# Staff Report

To: Salt Lake City Planning Commission  
From: Kelsey Lindquist, Senior Planner, [kelsey.lindquist@slcgov.com](mailto:kelsey.lindquist@slcgov.com) or (801) 535-7930  
Date: May 24, 2019  
Re: PLNPCM2019-00037 Green Street ADU

## Conditional Use

## **Second** BUILDING CODES PLAN REVIEW

SHEET NUMBER:  
**P-2**

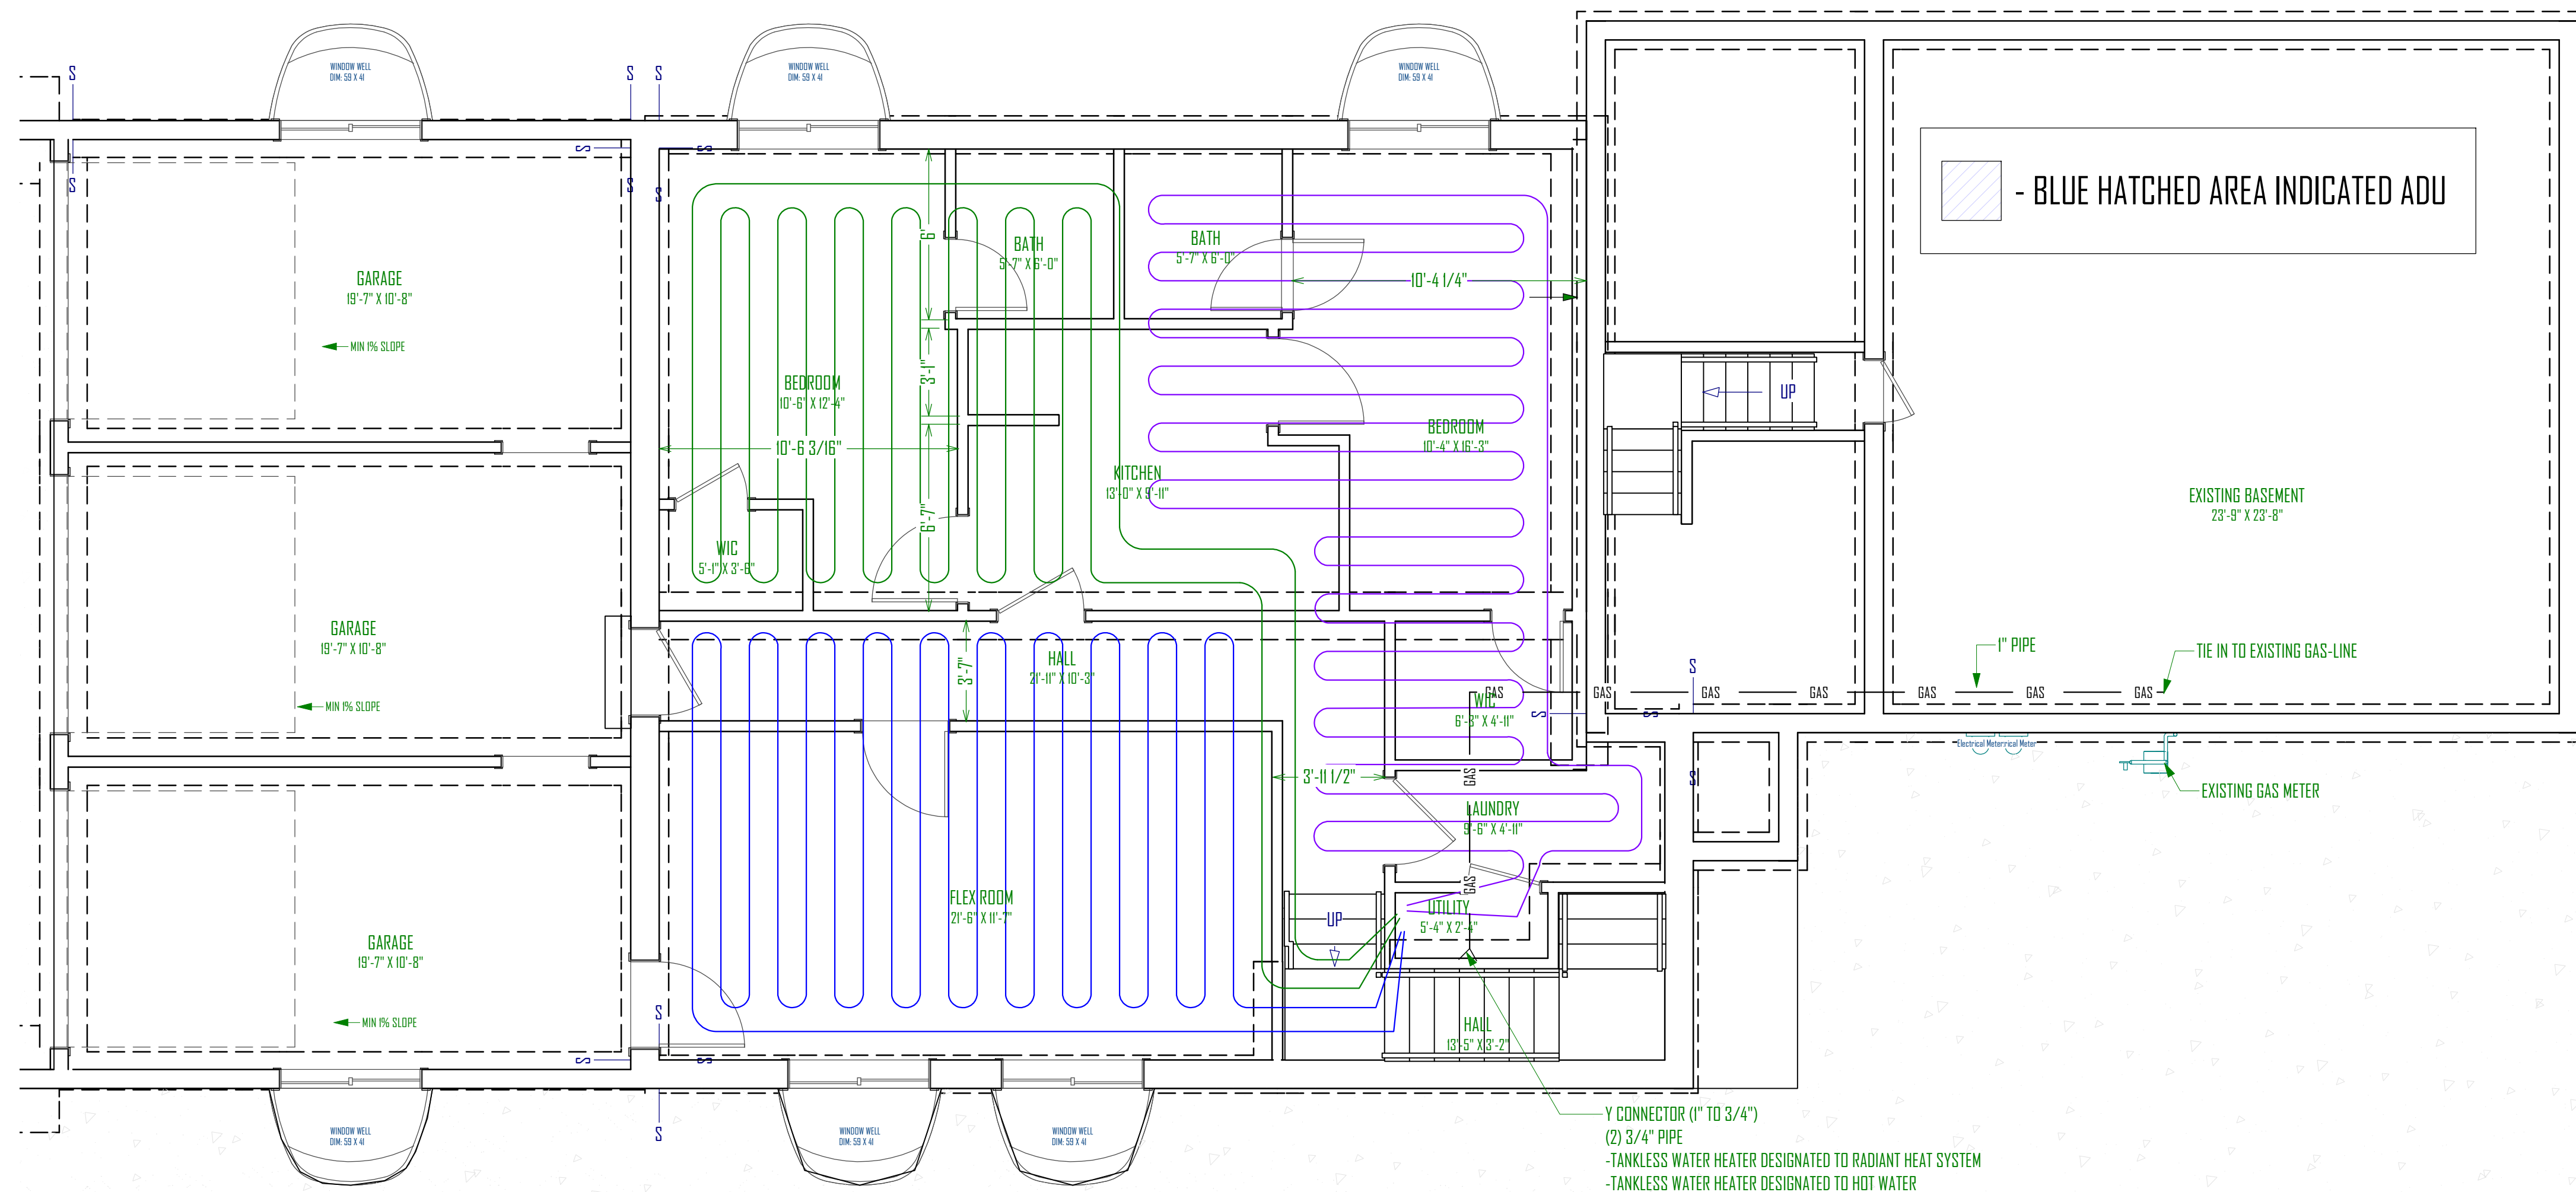
- 10. Notes on sheets P-2 and P-3 indicate a hydronic radiant heat system. In addition to the layout drawings in the set, provide a complete submittal for the proposed hydronic system. **Resolved.**

10. Notes on sheets P-2 and P-3 indicate a hydronic radiant heat system. In addition to the layout drawings in the set, provide a complete submittal for the proposed hydronic system.

- Please see added schematic on sheets P-2 & P-3
